Council's previous submissions on this development raised concerns regarding the long term impacts of the carparking solutions for this development. In particular the provision of above-ground parking, surface and multi-storey, to the north of the site on prime potential recreation grounds that are adjoining and upland of bushland and riparian areas, and visible from the residential areas across the valley.

3) A minor alteration to the approved location and internal flow of the multi-deck carpark (bringing the structure closer to the hospital wings and allowing pedestrian access at the one level); and

**PLEASE REFER TO ATTACHMENTS 1,2,3,4,5 – mark ups of drawings**

**Table 1 – Alterations to Levels of the Modified Multi-Deck carpark**

Approved - Lot 1 - below grade.

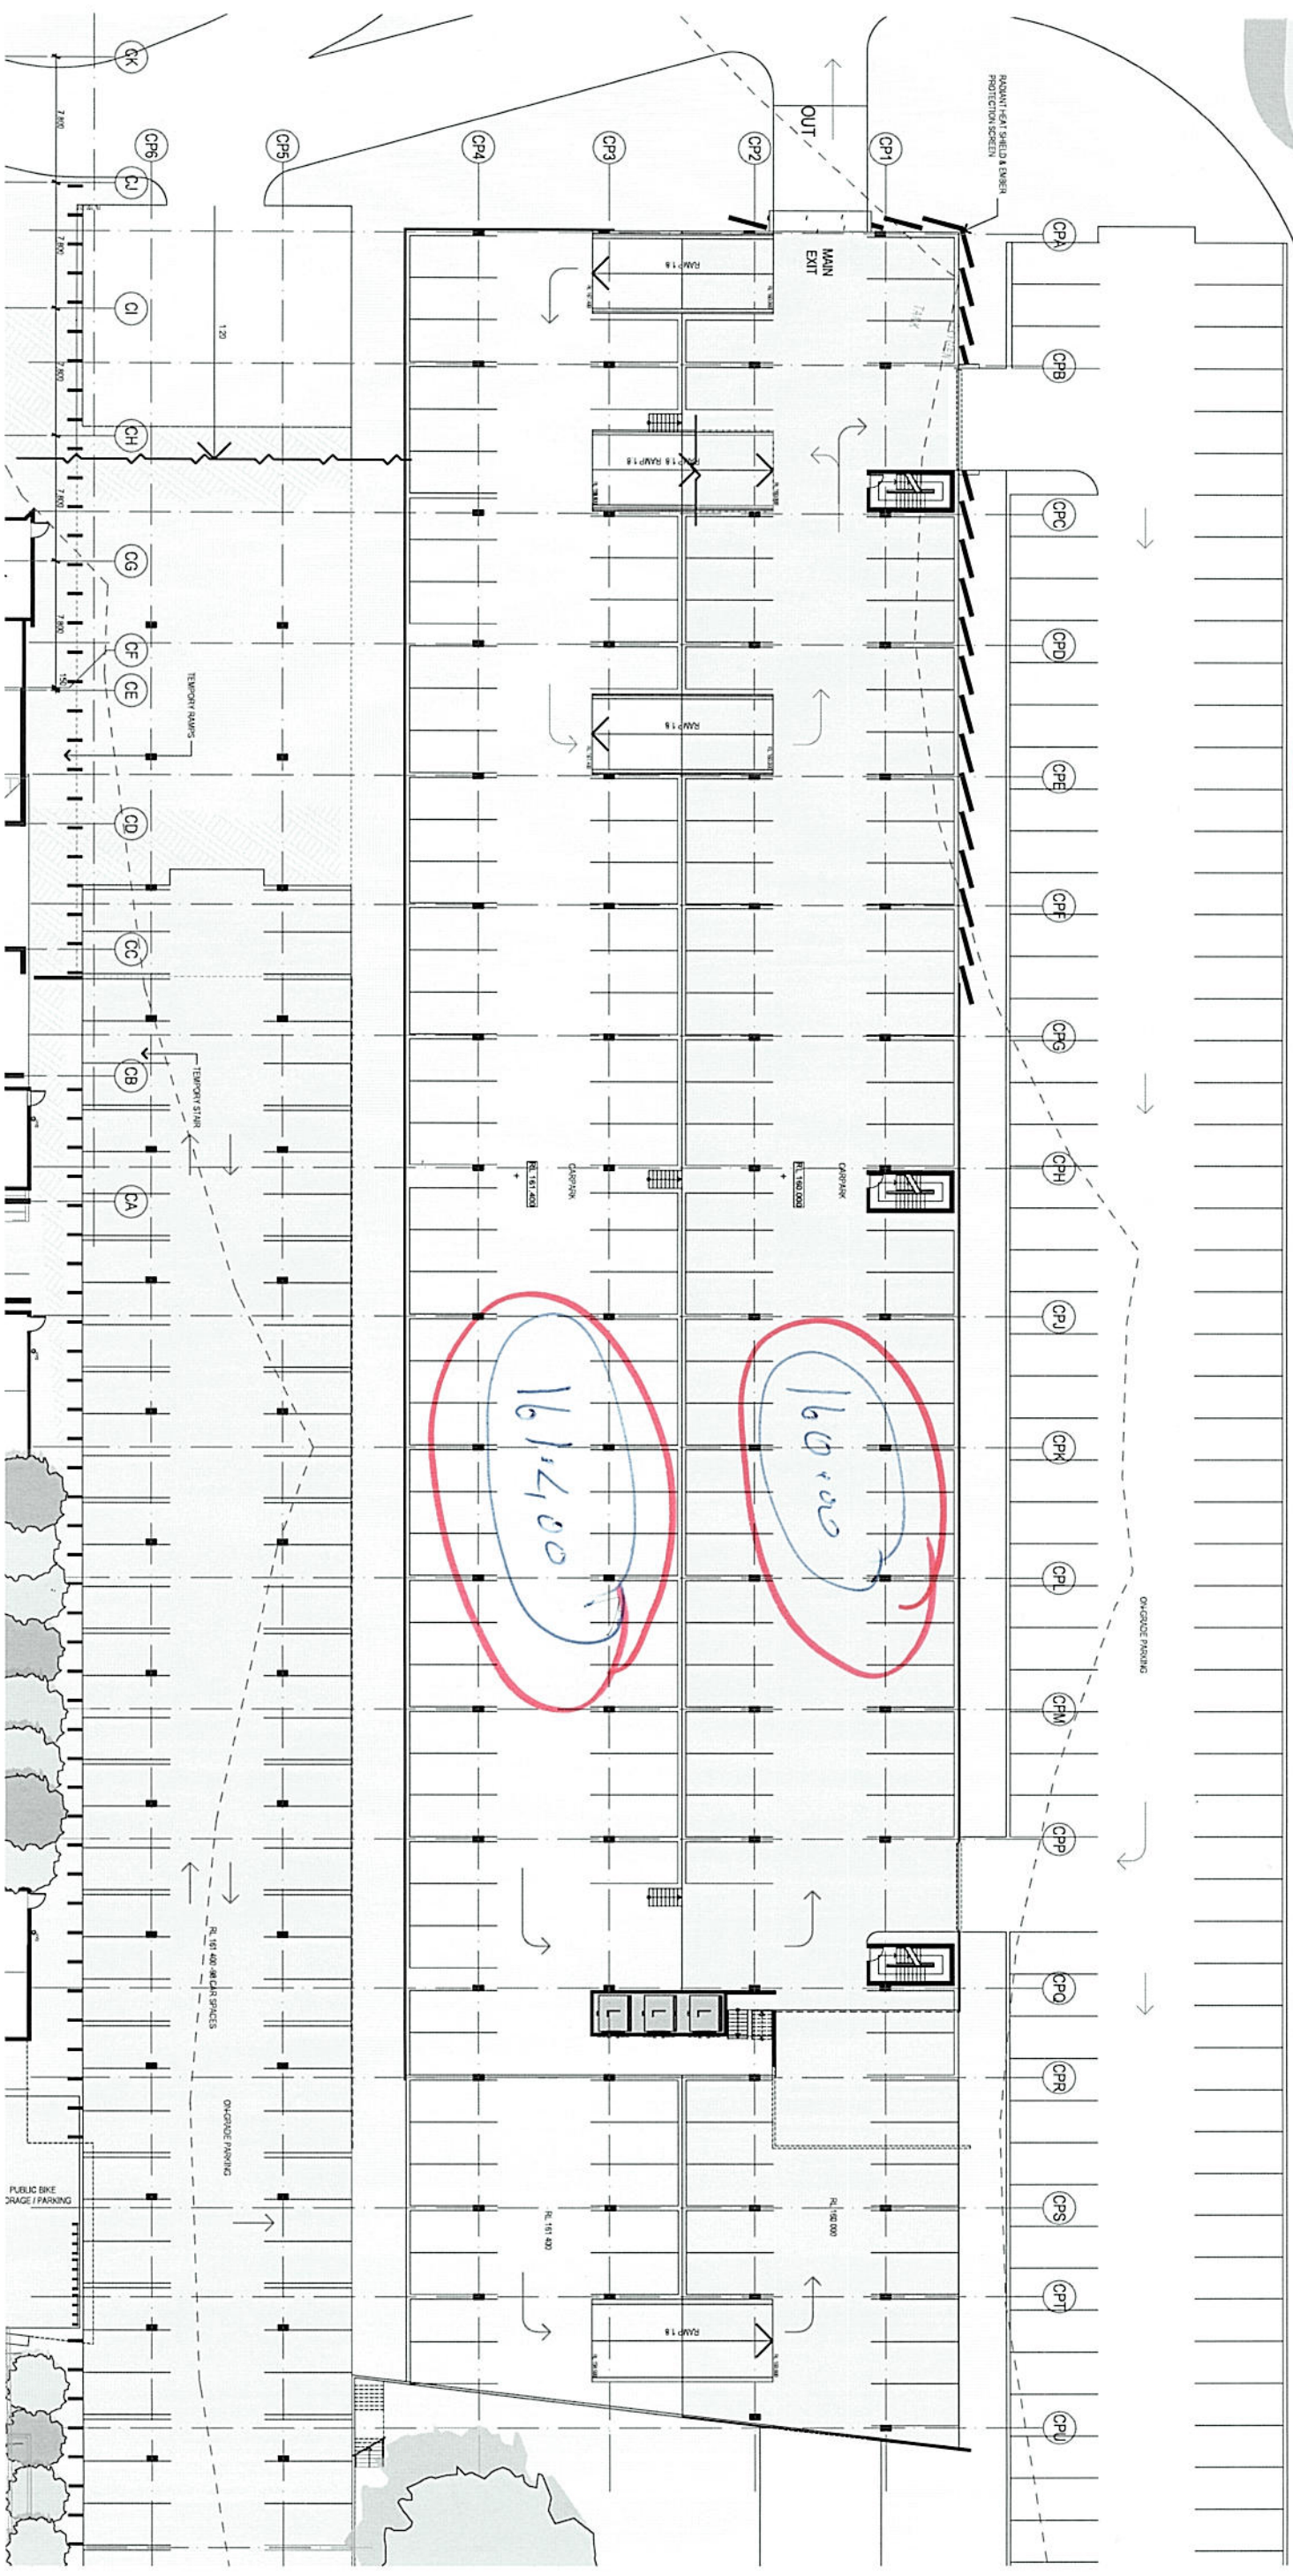
pool landscaping

APPROVED - elevations - CARPARK

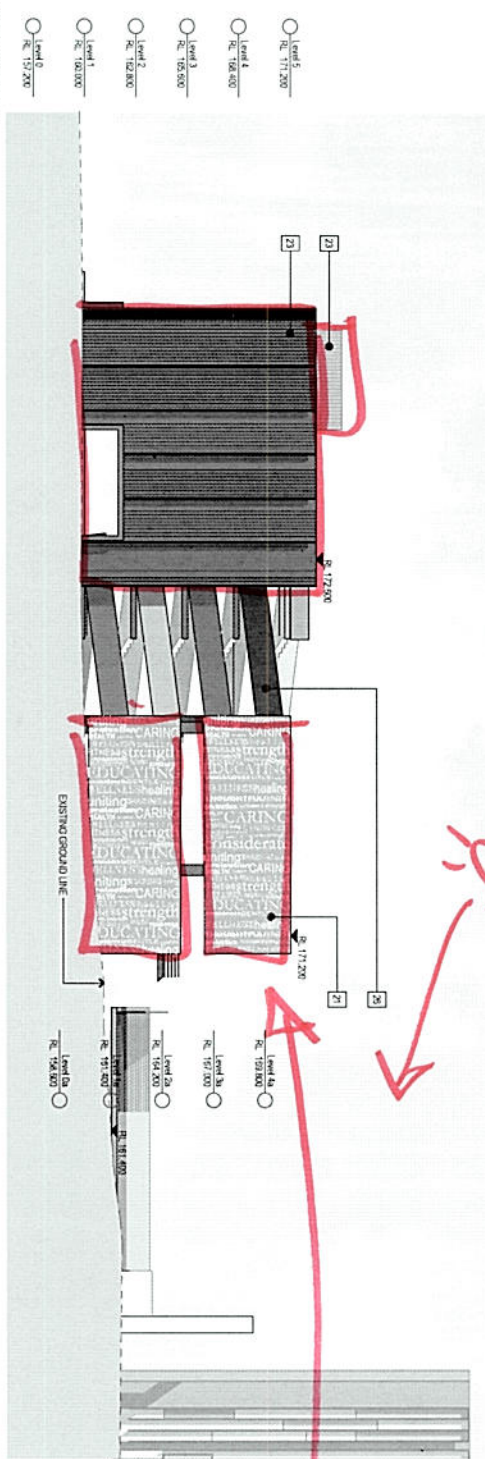
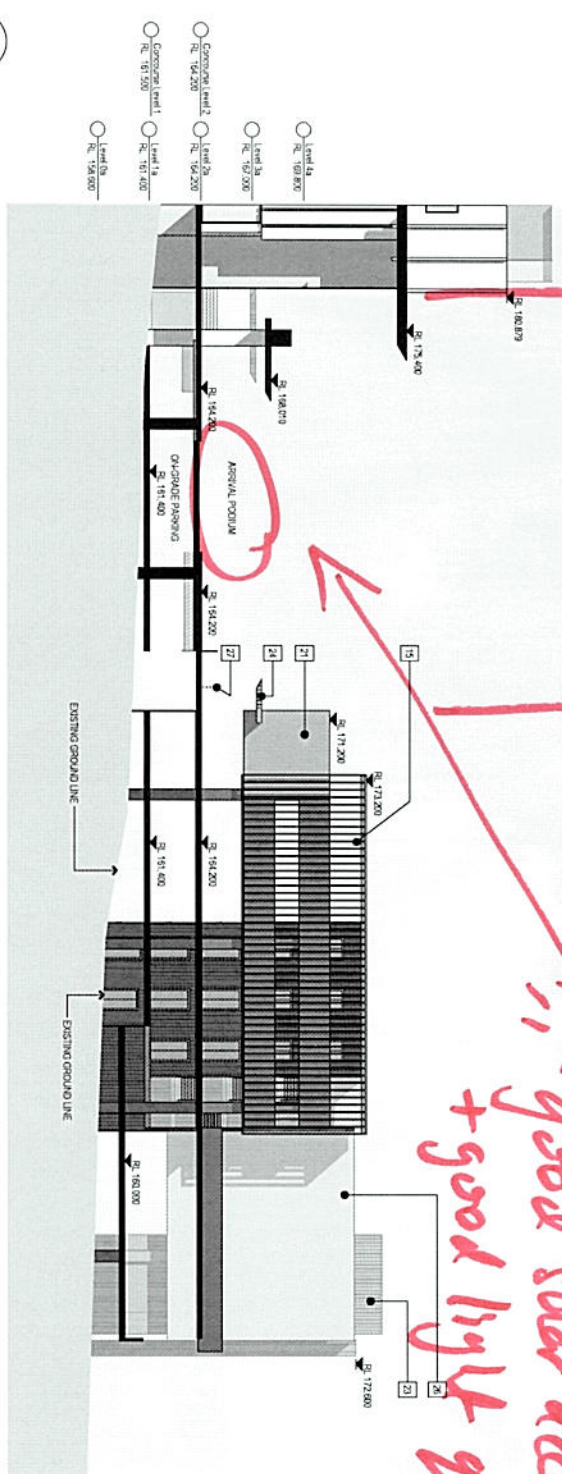
good open areas to main hospital building

Good Distance BETWEEN HSP + CARPARK IN APPROVED DESIGN.

good solar access + good light quality and spatial quality of 'Arrival Podium'

Building elevations broken down by level changes; material use; and separation; building elements; in visually interesting and reduced bulk/scale / appears of carpark.

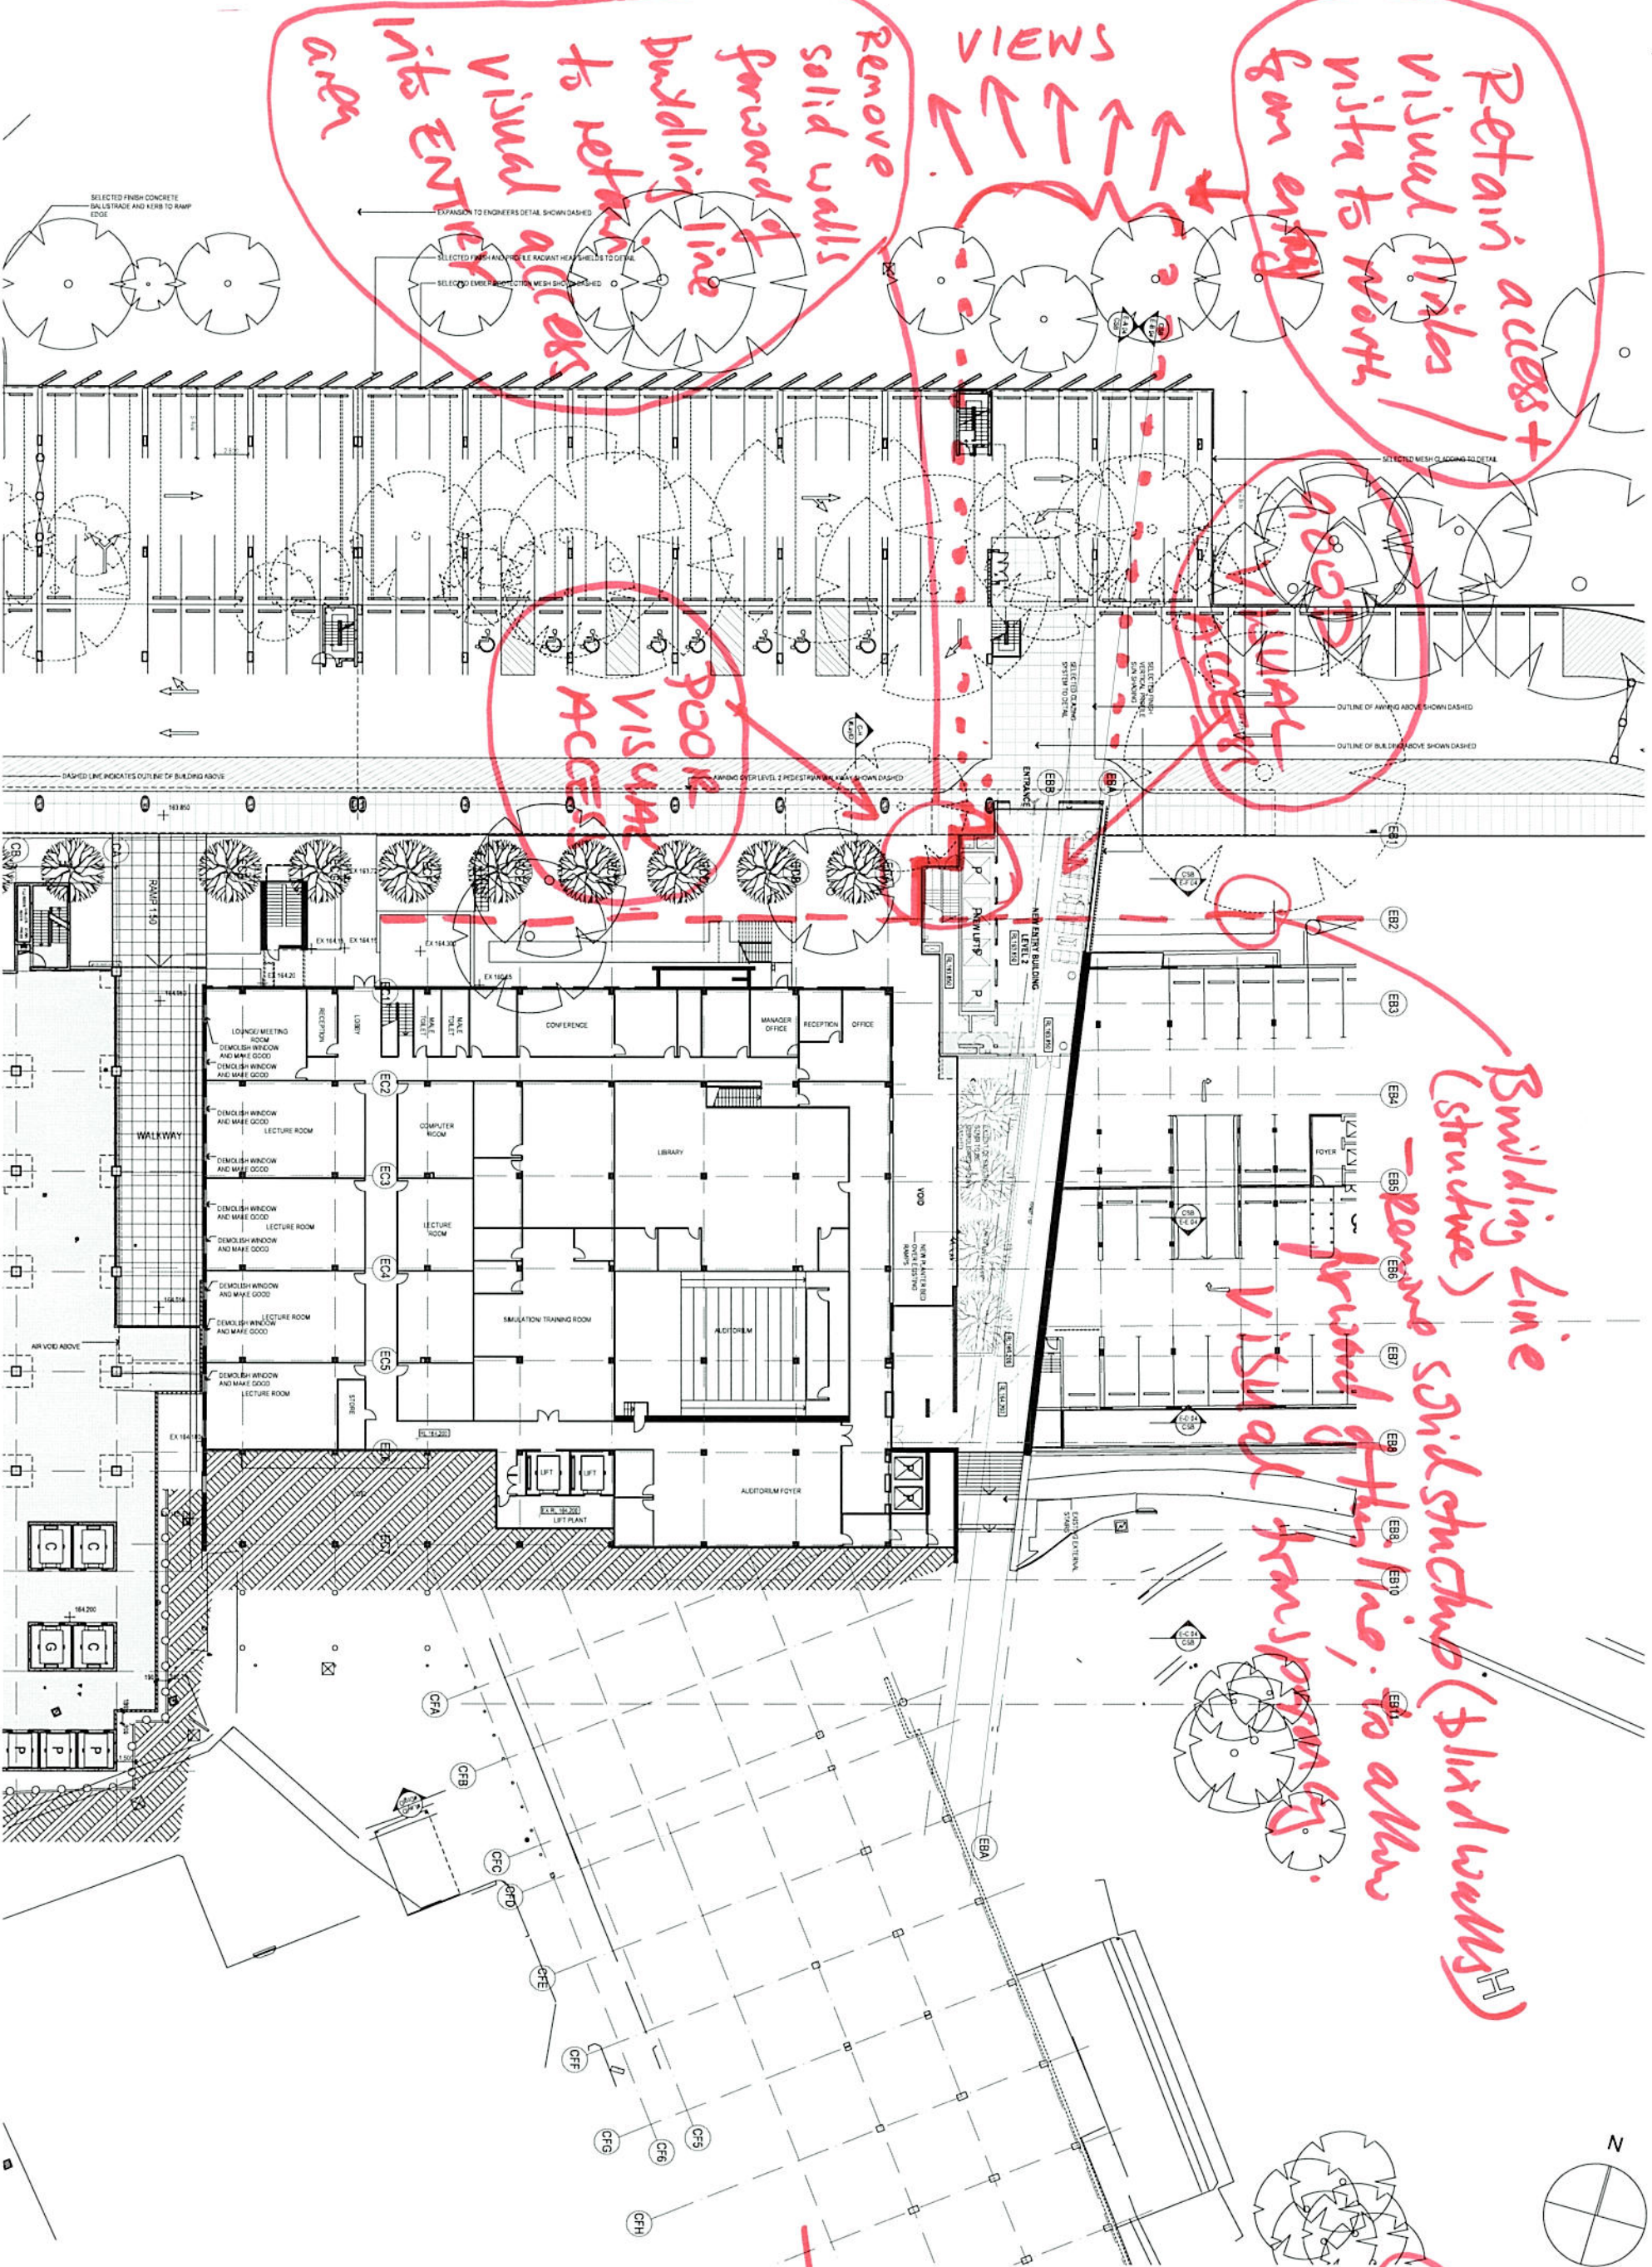
- RESULTS in poor social ACCESS to entry space

4.5m ~~minimum~~ HEIGHT  
OF ENTRY AREA INTO  
MAIN HSR. ENTRY FROM  
CARPARK
